RTCA Special Committee 209, Working Group #1

Mode S Transponder MOPS Maintenance

**Detailing The Proposed Changes to Figures in
Order to Harmonize DO-181D and ED-73C**

**(This version was created after WG-1 Meeting #3 to add some Figures and clarifications before
sending to WG-49 for their November meeting)**

Figure 2-12(A)R1: WITH CHANGES PROPOSED TO HARMONIZE WITH ED-73C Figure 3-11 for SIS=0

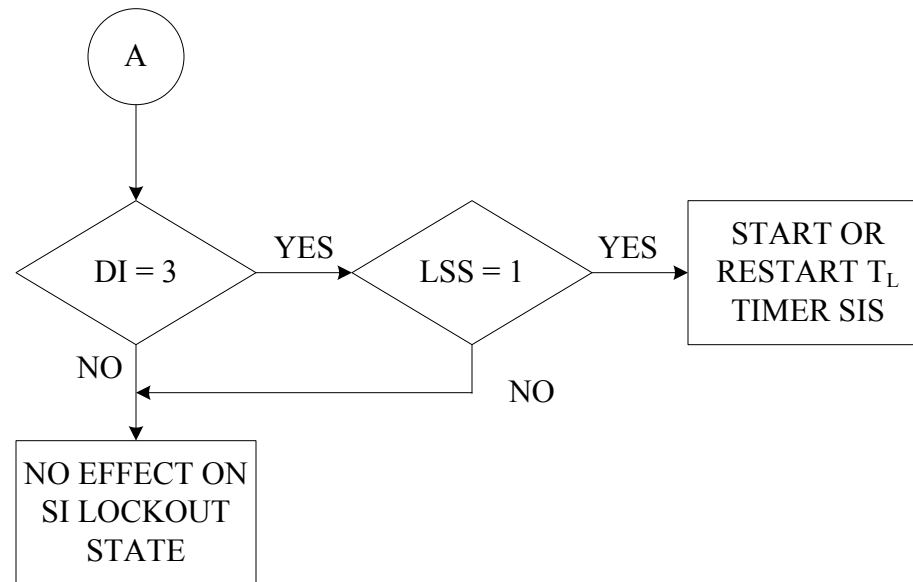
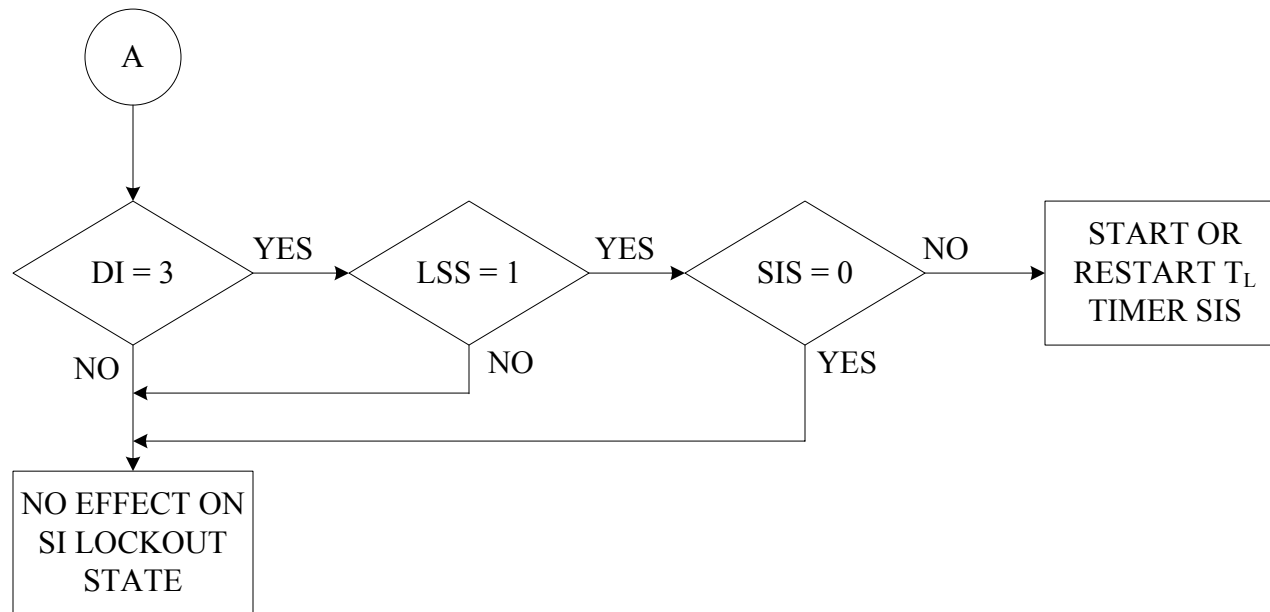
5. Figure 2-12(A) in DO-181D differed from Figure 3-11 in ED-73C because it appears that Figure 3-11 had a decision box for SIS=0 and Figure 2-12(A) had not been updated. Therefore Figure 2-12(A) is shown below as the original, and Figure 2-12(A)R1 is shown as modified to account for the addition of the blocks for SIS=0.

Figure 2-14R1: WITH CHANGES PROPOSED TO HARMONIZE WITH ED-73C Figure 3-13

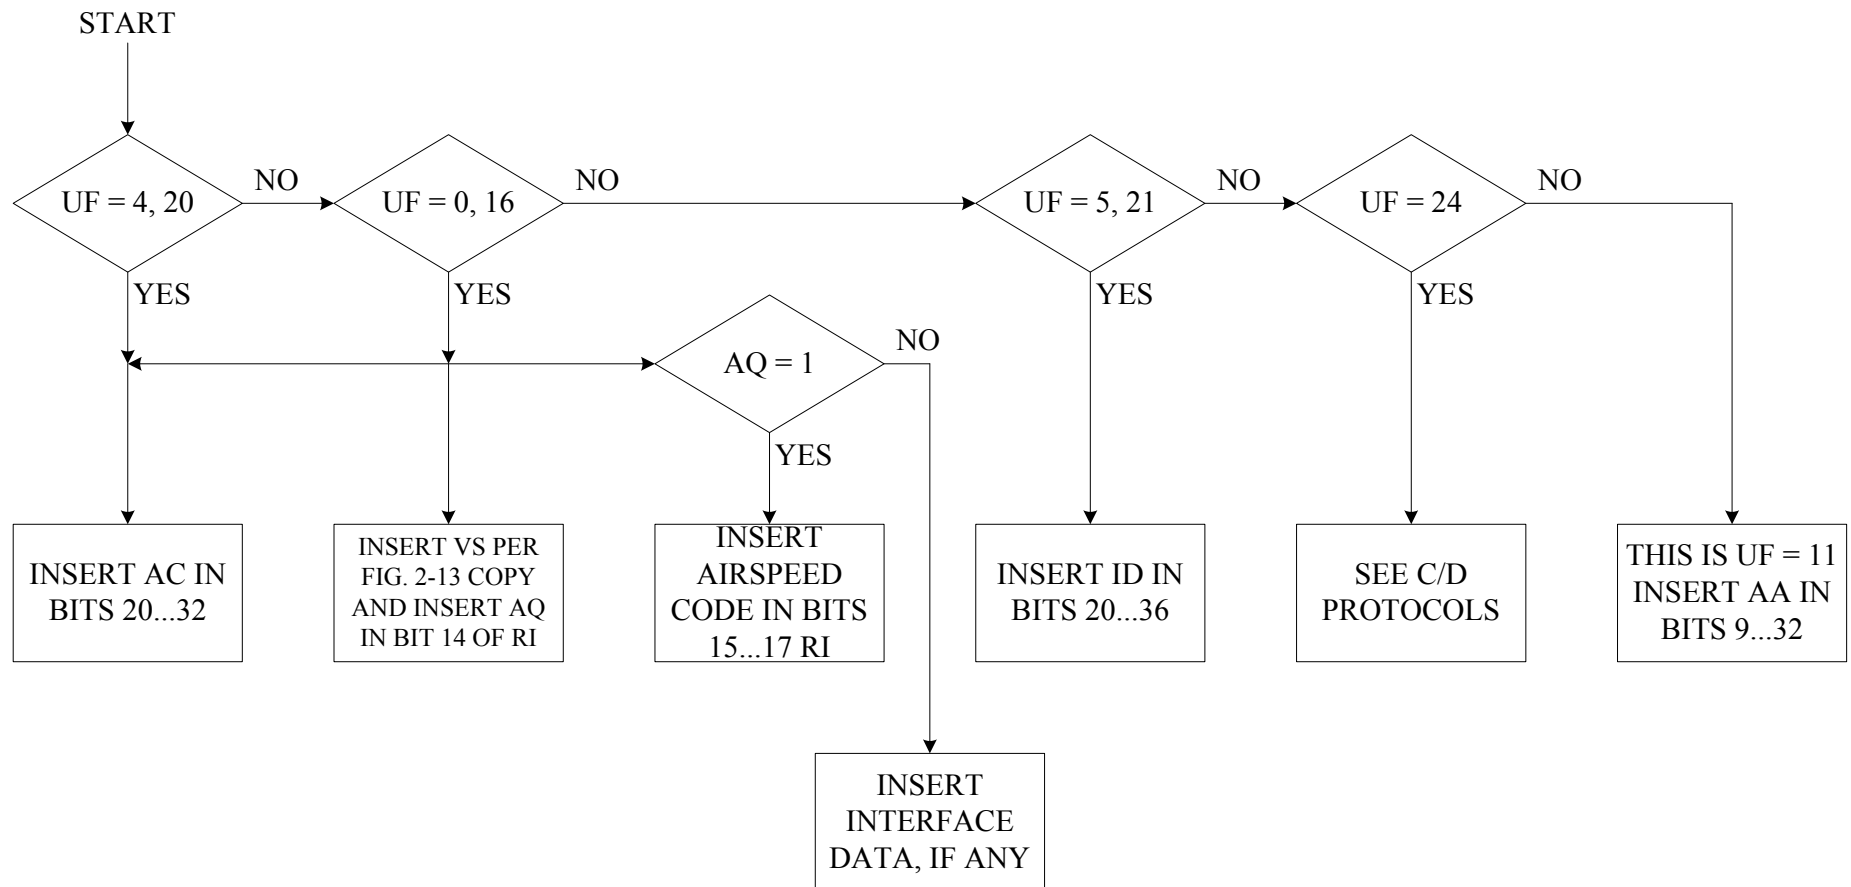
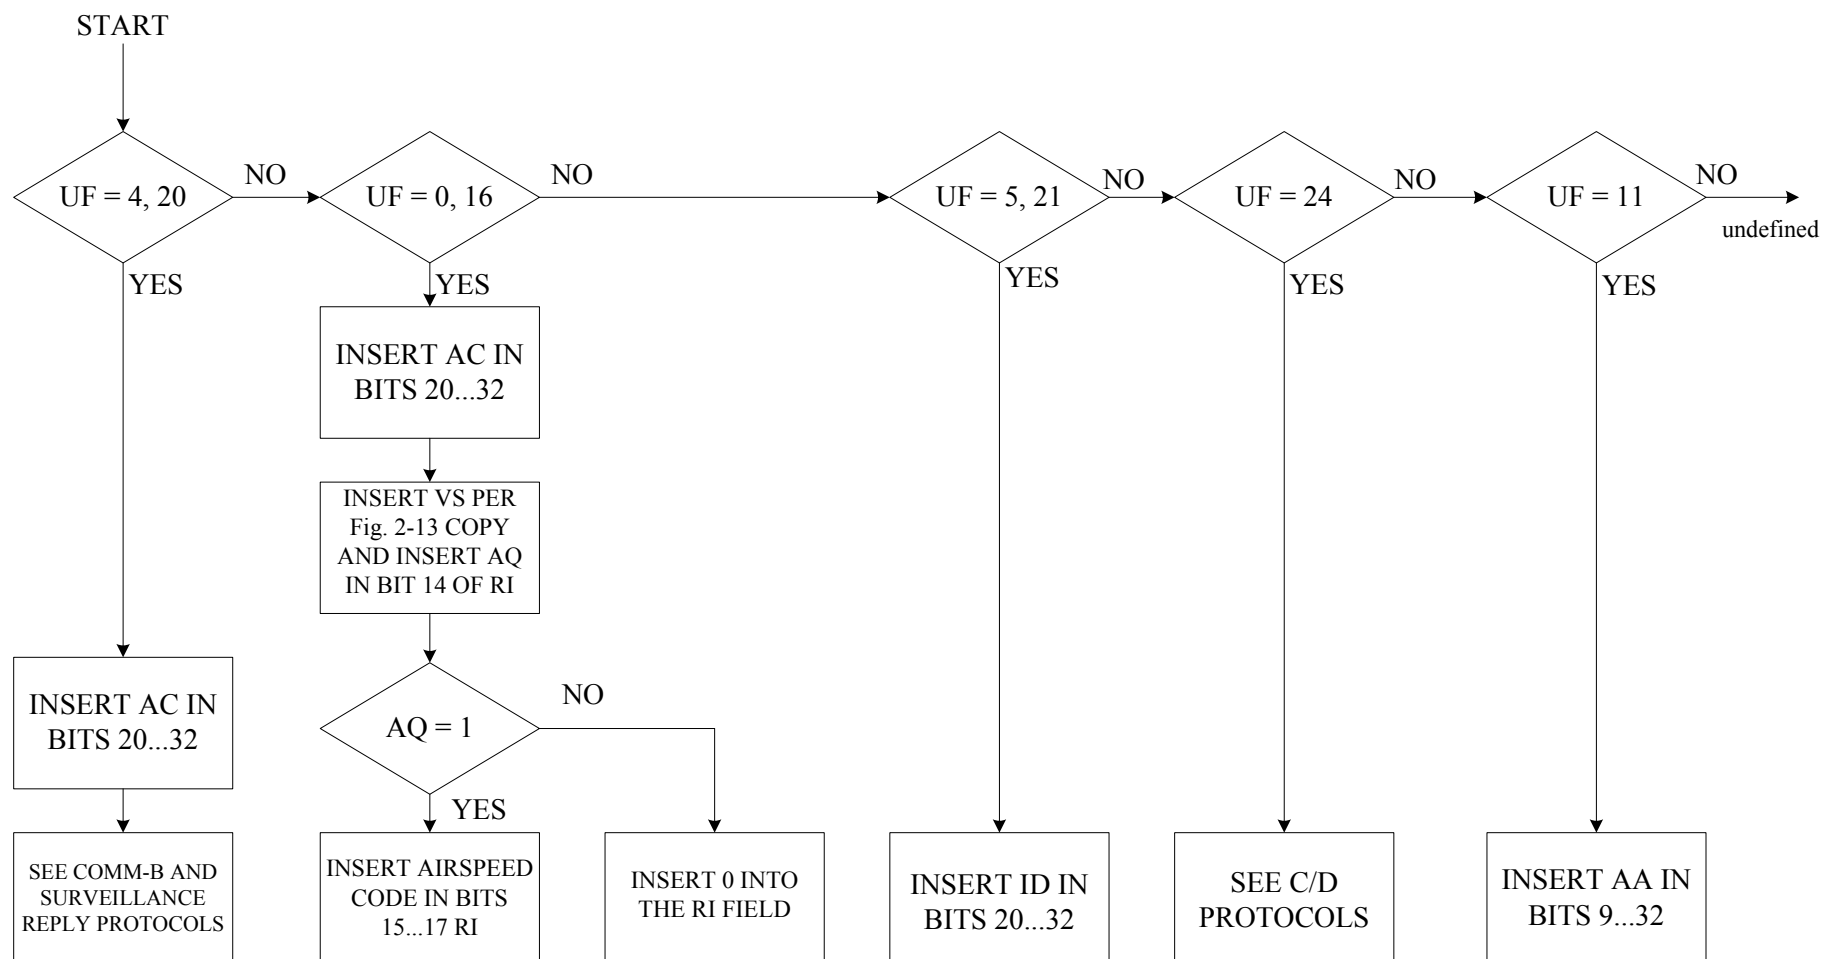
7. After analysis it appears that Figure 2-14 in DO-181D has several errors, and that Figure 3-13 in ED-73C is correct. Therefore, Figure 2-14R1 is proposed to be updated to match Figure 3-13 as shown below.

Figure 2-16R2: WITH CHANGES PROPOSED TO HARMONIZE WITH ED-73C Figure 3-15 with SI Protocol

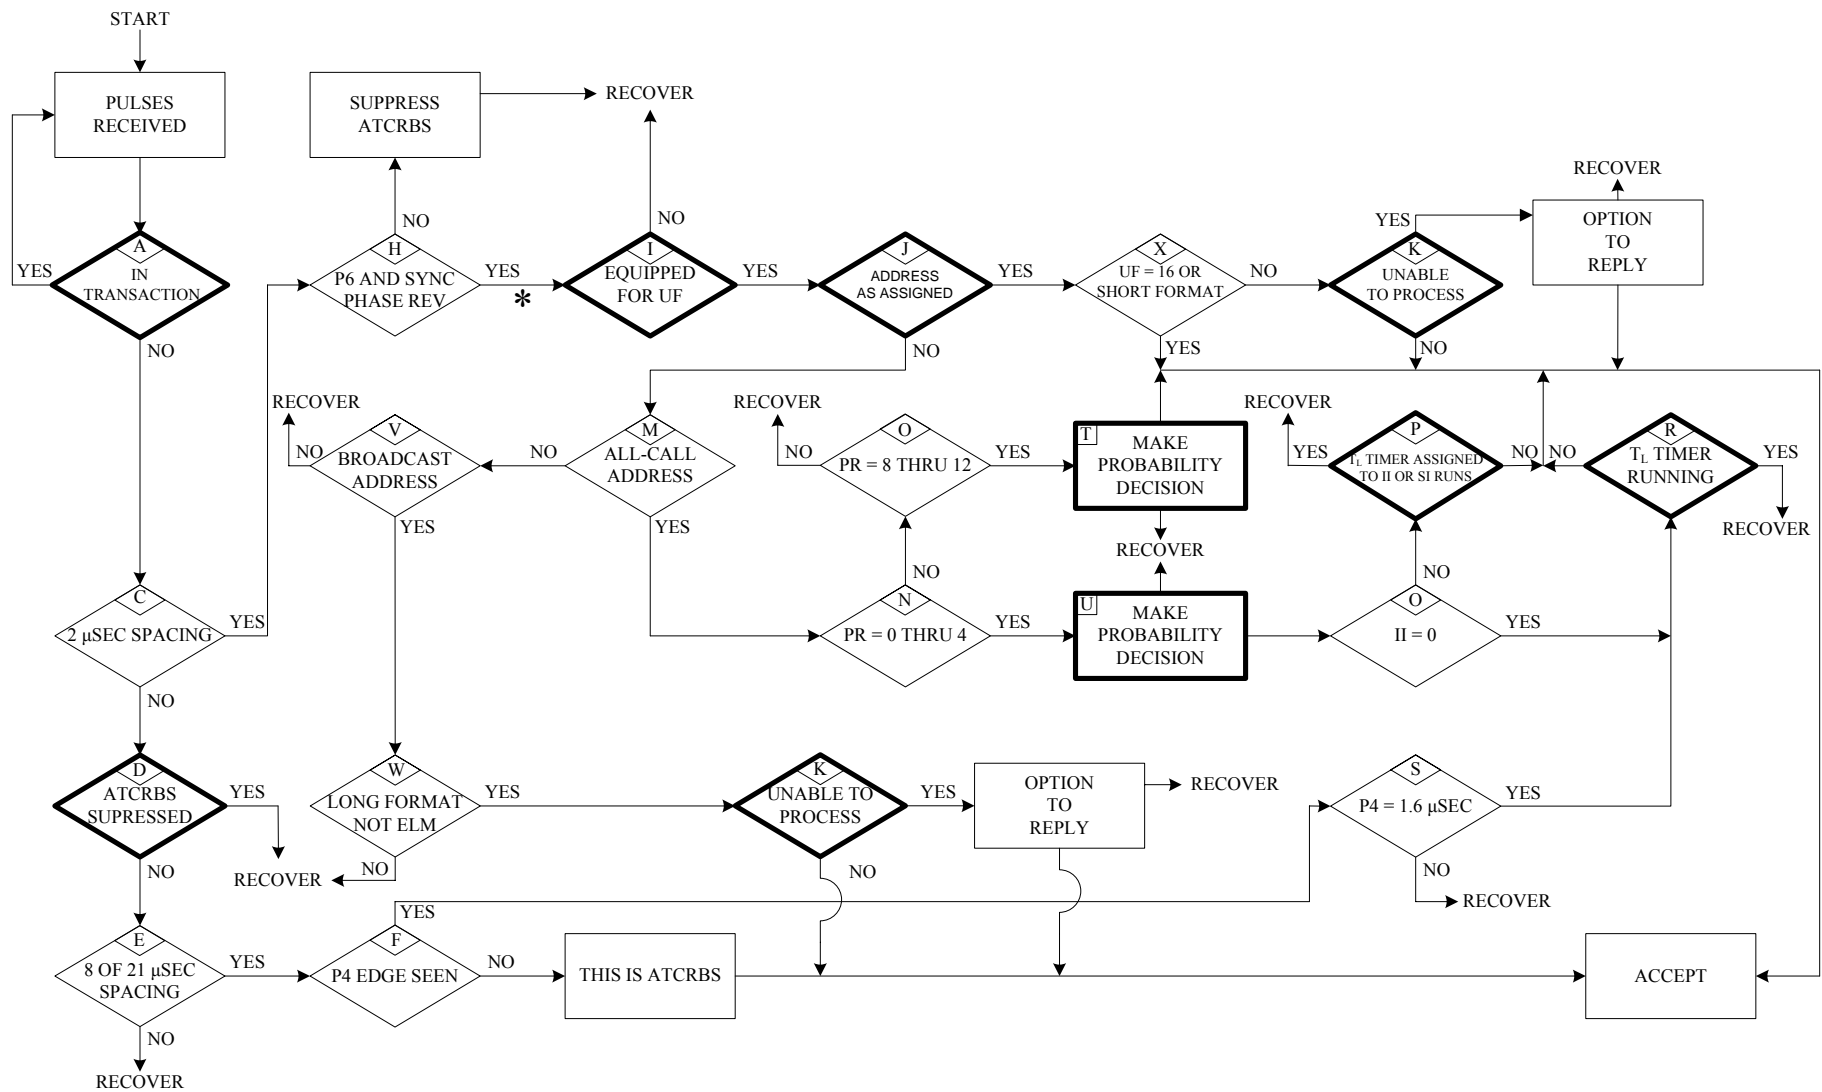
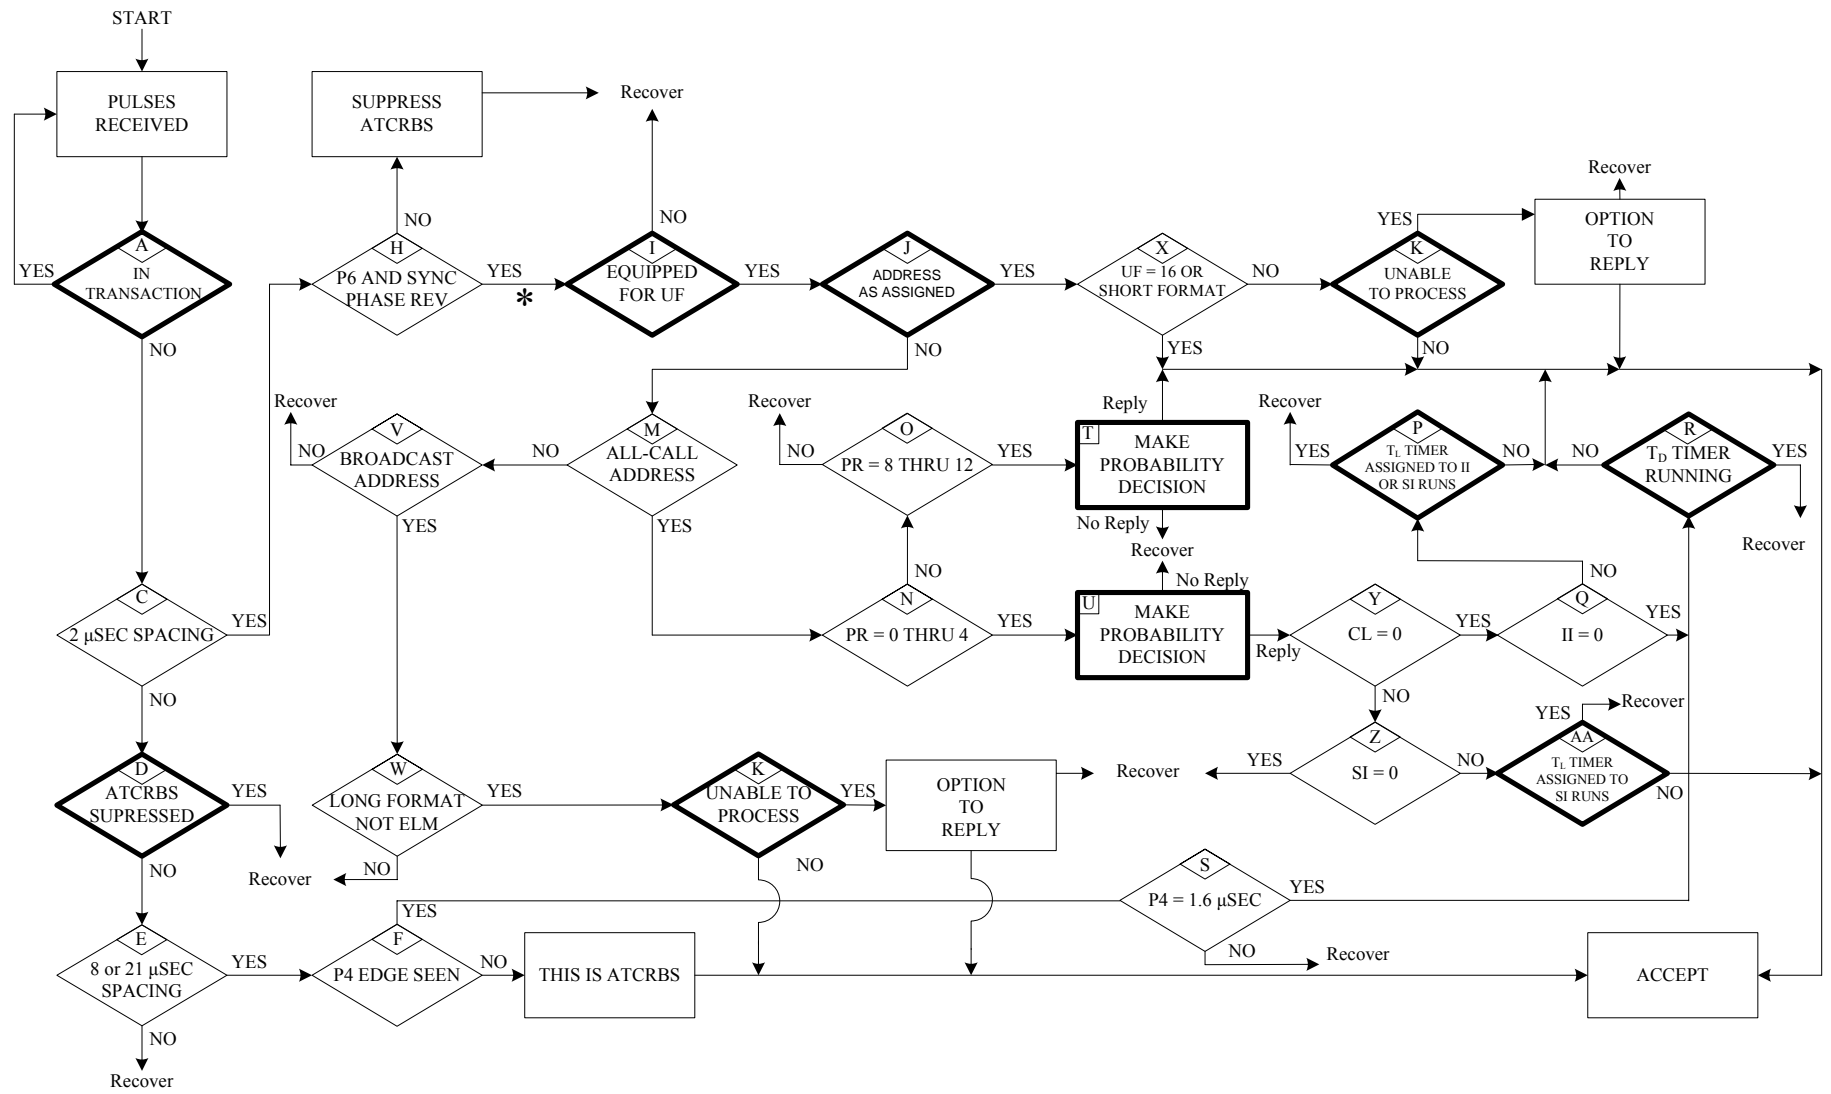
8. Figure 2-16 in DO-181D differed from Figure 3-15 in ED-73C because it appears that Figure 3-15 had been updated to add the decision boxes for SI protocol and Figure 2-16 had not been updated. Figure 2-16R1 was presented during the Brussels meeting showing two “Option to Reply” decision boxes proposed to be added by Tom Pagano, and they are retained in the Figures below. Therefore Figure 2-16R1 is shown below as the “original,” and Figure 2-16R2 is shown below as modified to account for the addition of the diamonds for SI protocol.

Figure 2-18: All Level 2 Transponders UM Protocol

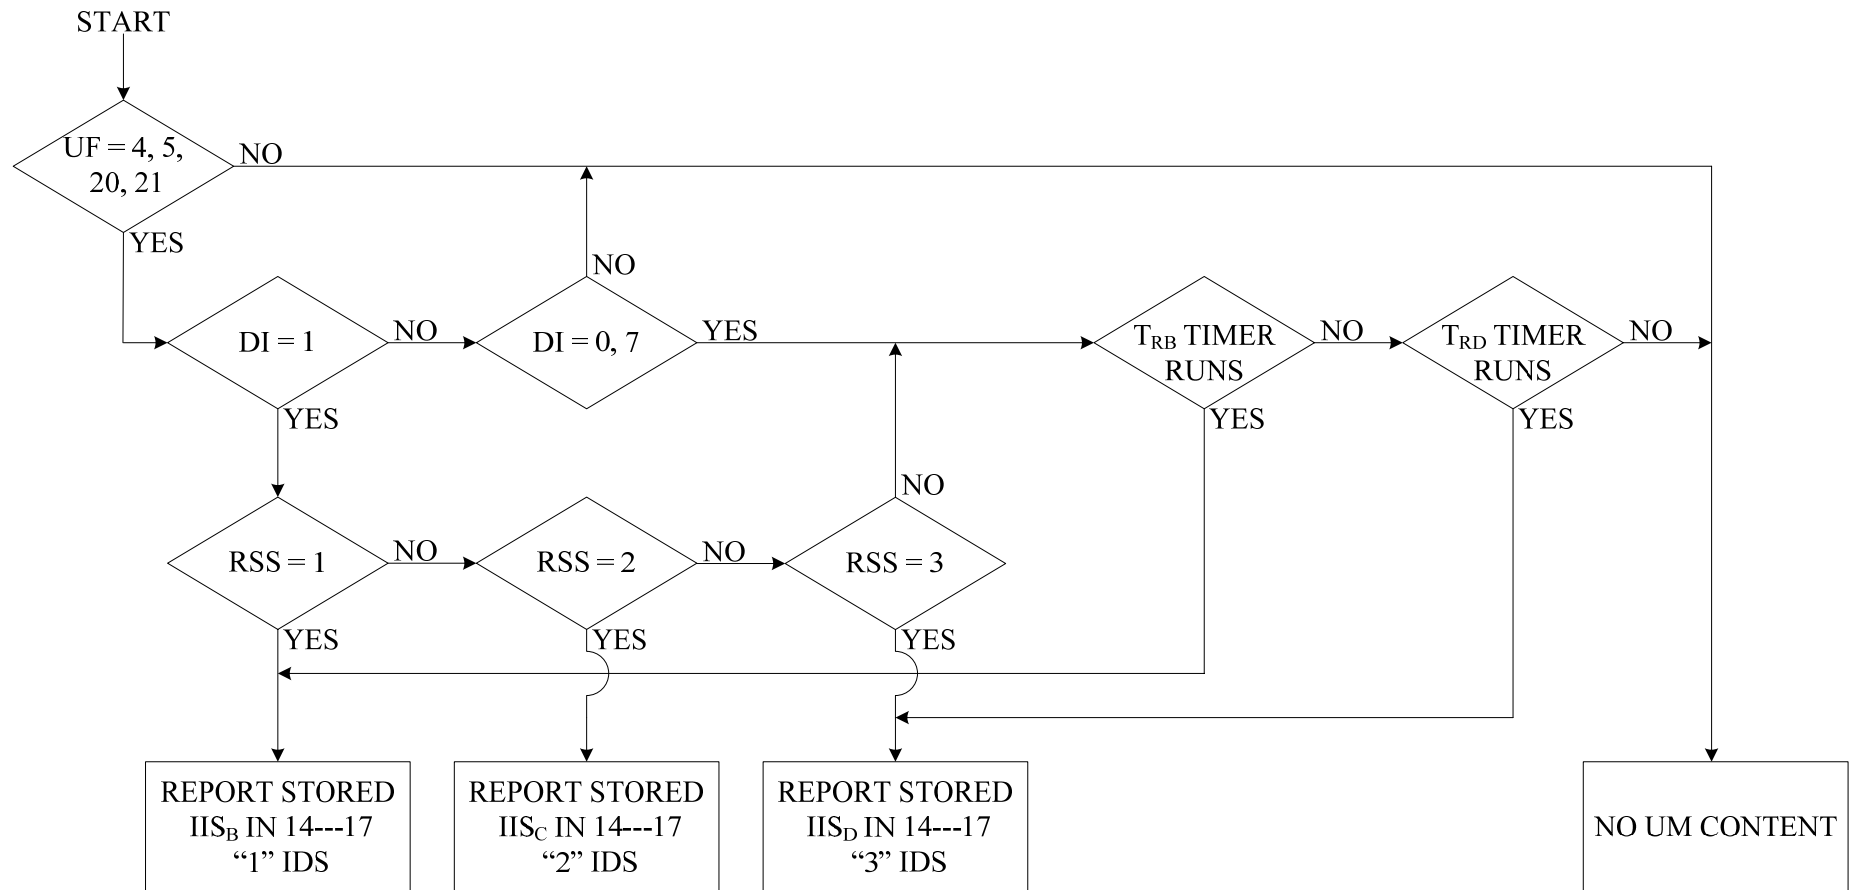
9. Figure 3-17 in ED-73C has a decision diamond indicating that “ T_{RS} Timer Runs.” That is incorrect, and it should be “ T_{RB} Timer Runs” as in Figure 2-18 of DO-181D, shown below.
